Southern California Edison Company

August 29, 1985

Subject: Docket No. 50-206
Control of Heavy Loads
San Onofre Nuclear Generating Station
Unit 1

SAFE LOAD PATHS
AND
SAFE LOAD ZONES
FOR
SAN ONOFRE UNIT 1

Load Zone for CRDM Ventilation Ducting With Missile Shield Removed and Head In Place

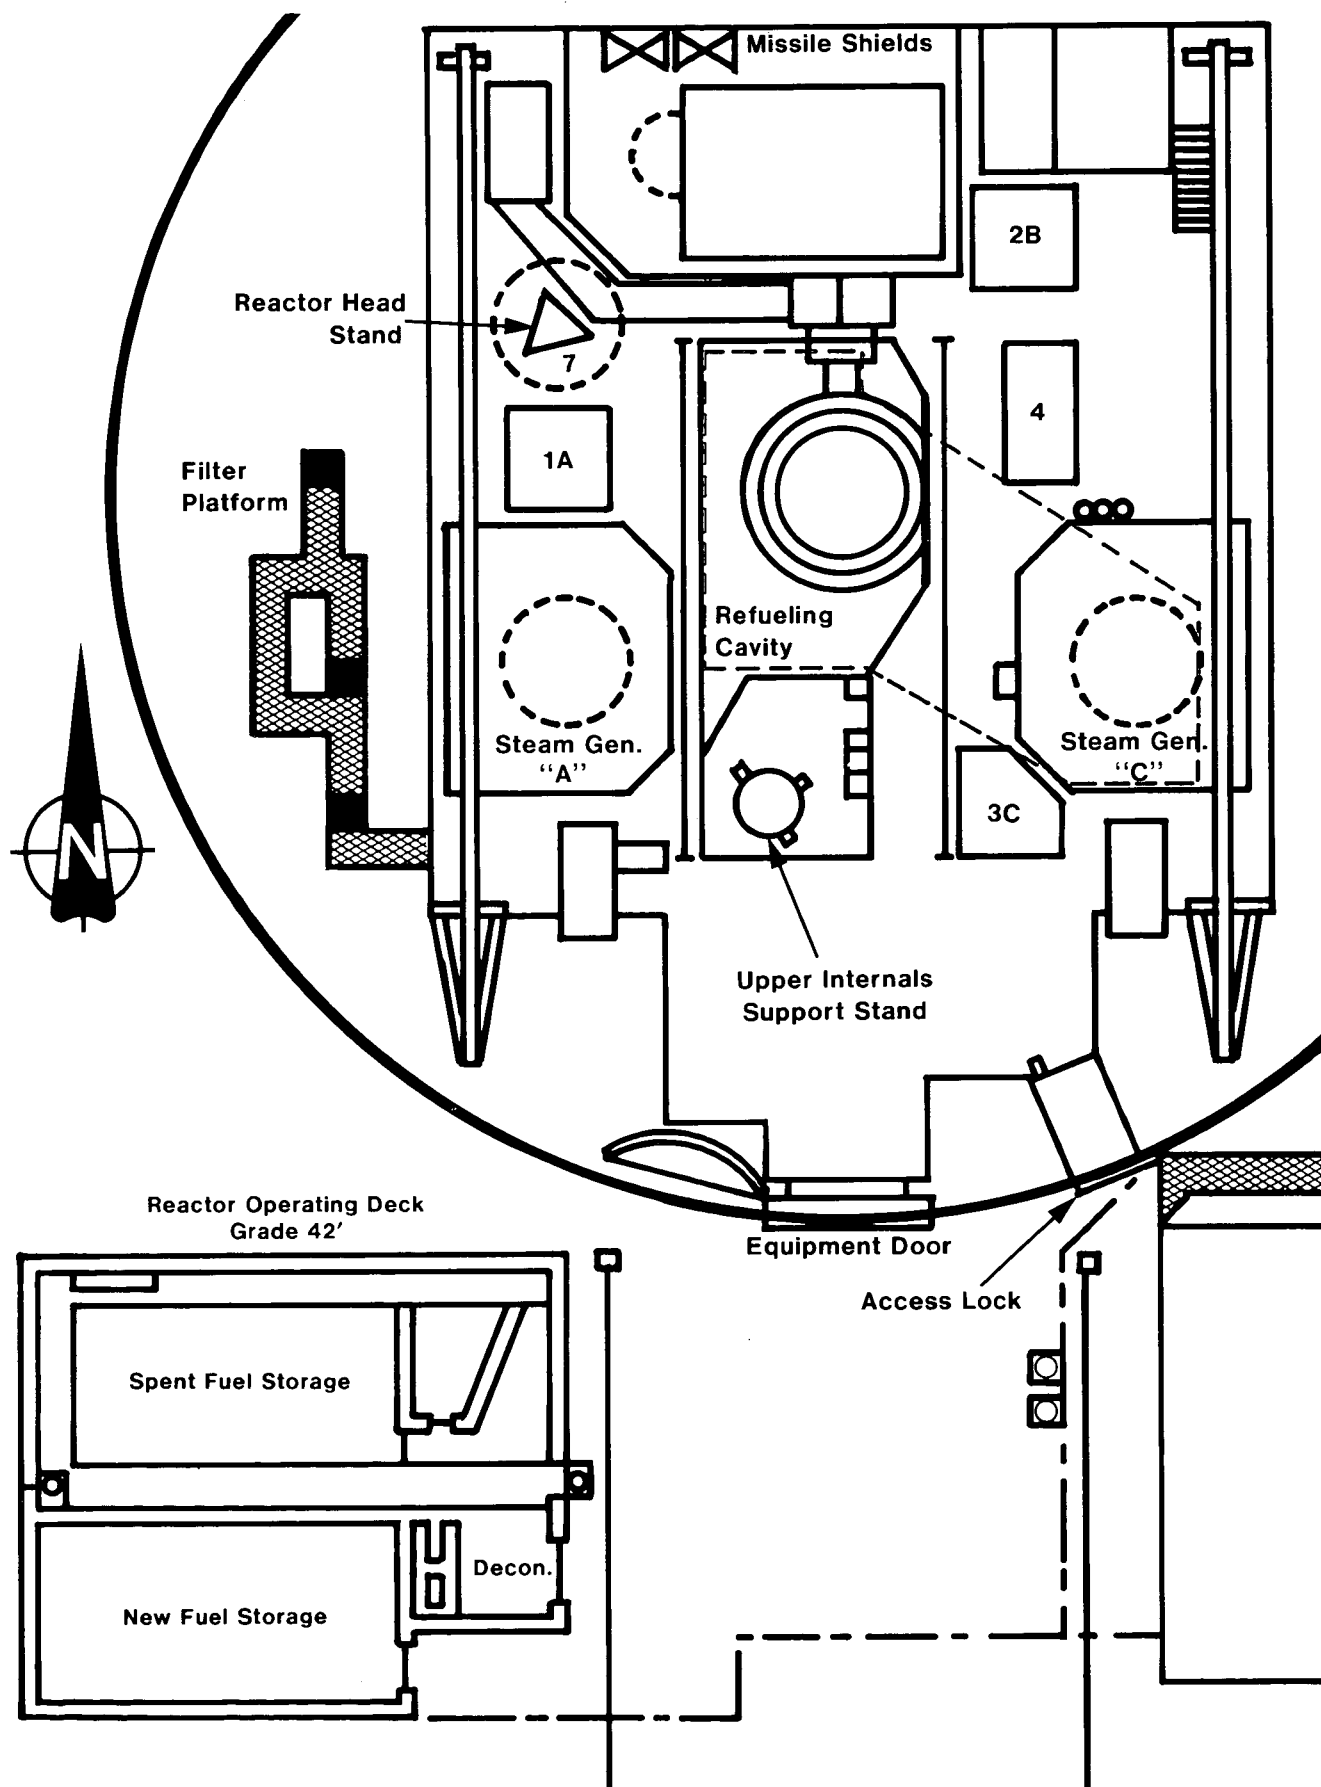
- (2) The CRDM ventilation ducts have an aggregate weight of greater than 1500 lbs, but each piece, when dismantled for removal prior to refueling, weighs on the order of 300 to 400 lbs. However, the load zone for the CRDM duct placement on top of the steam generator doghouse was included since it involves a lifting operation of significant height (i.e., approximately 30 feet) over the refueling deck.

Load Zone for Seal Ring Supports With Head On, Shield Off

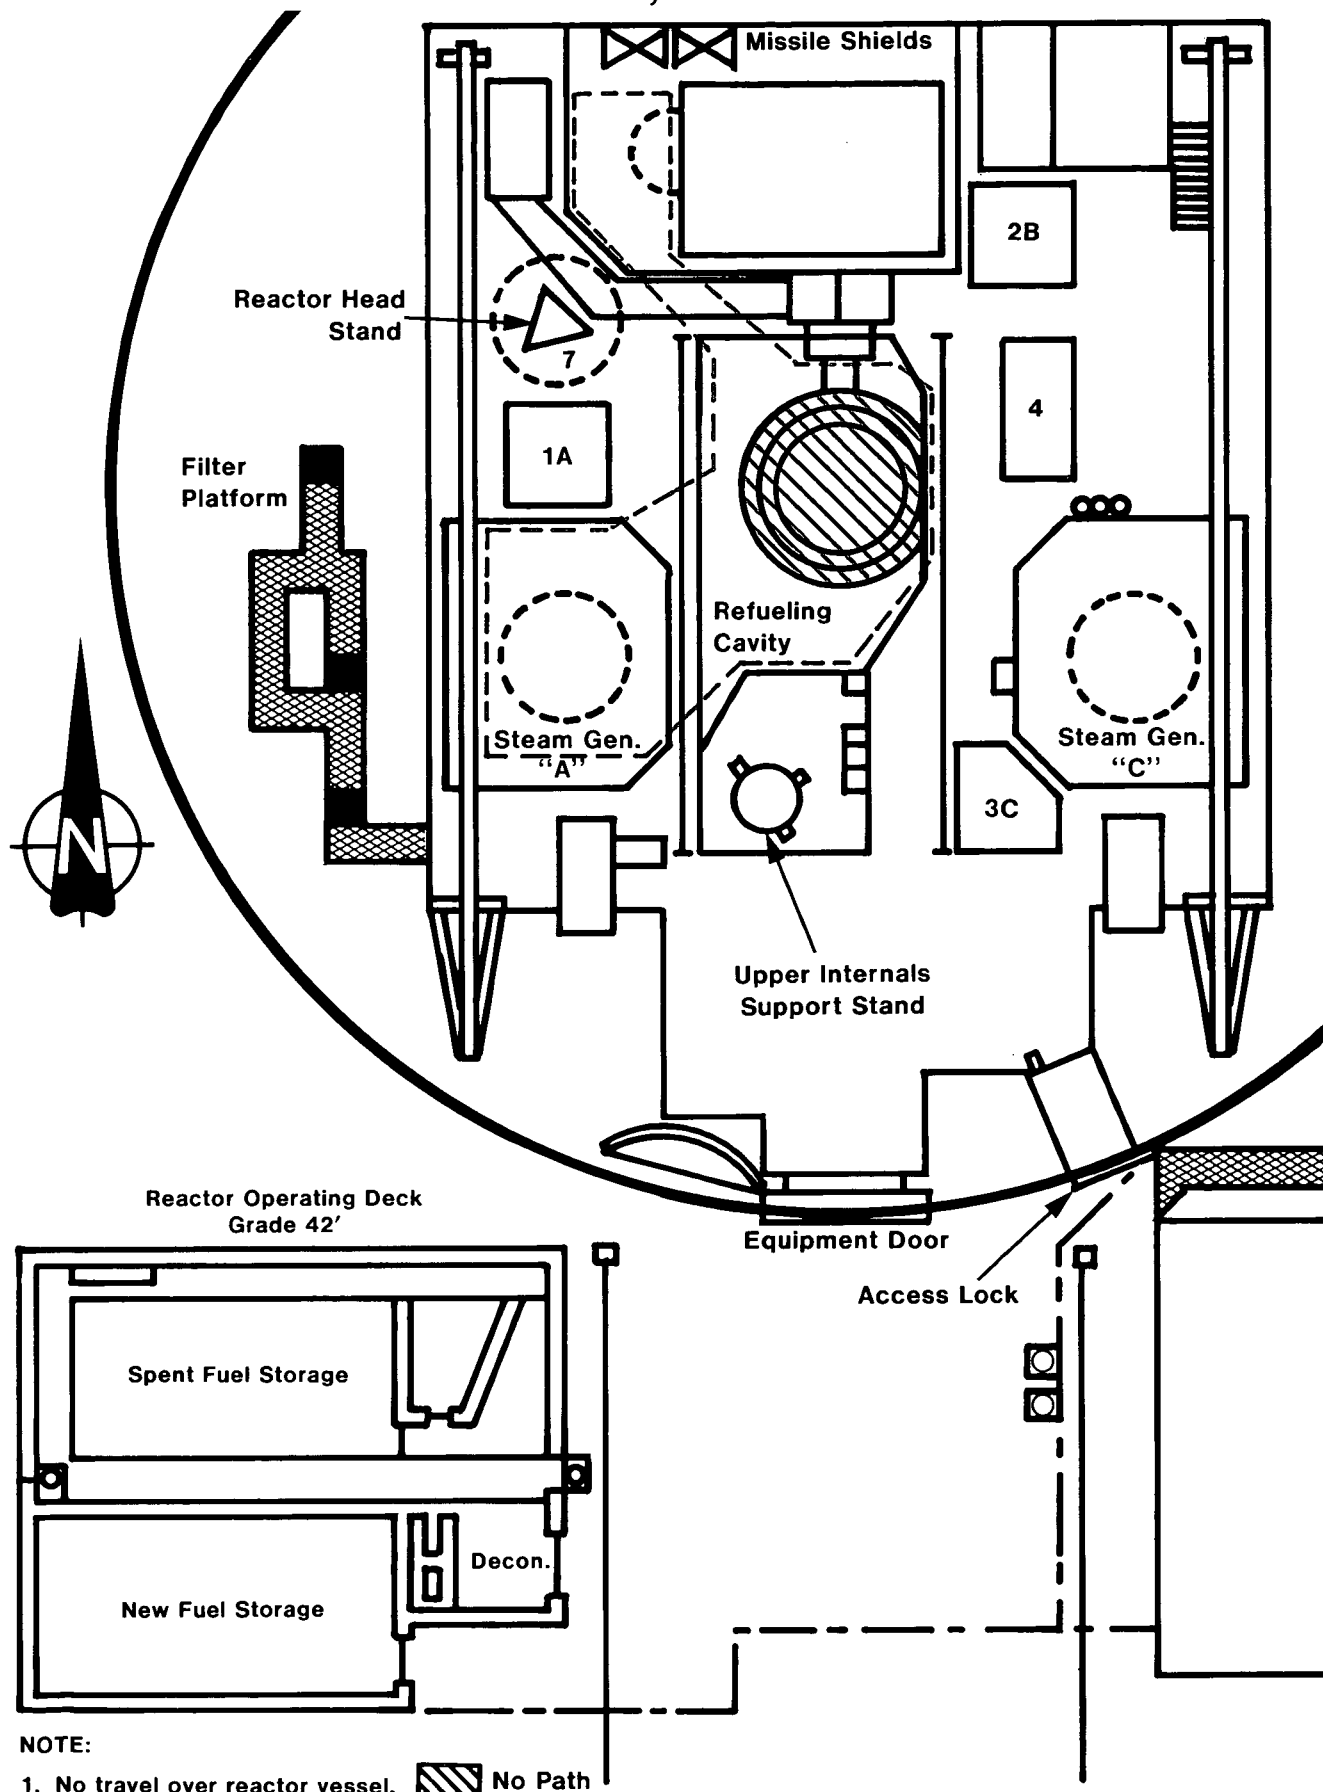
- (3) The elevation -10 ft. access and the RCP motor access plugs were referred to as equipment hatches in our previous submittals.
- (4) The new heavy loads identified in the figures (the guide studs, the seal ring supports and the pressurizer relief valves) are all small, approximately 2000 to 3000 lb. loads, and are handled with normal rigging, using standard procedures.
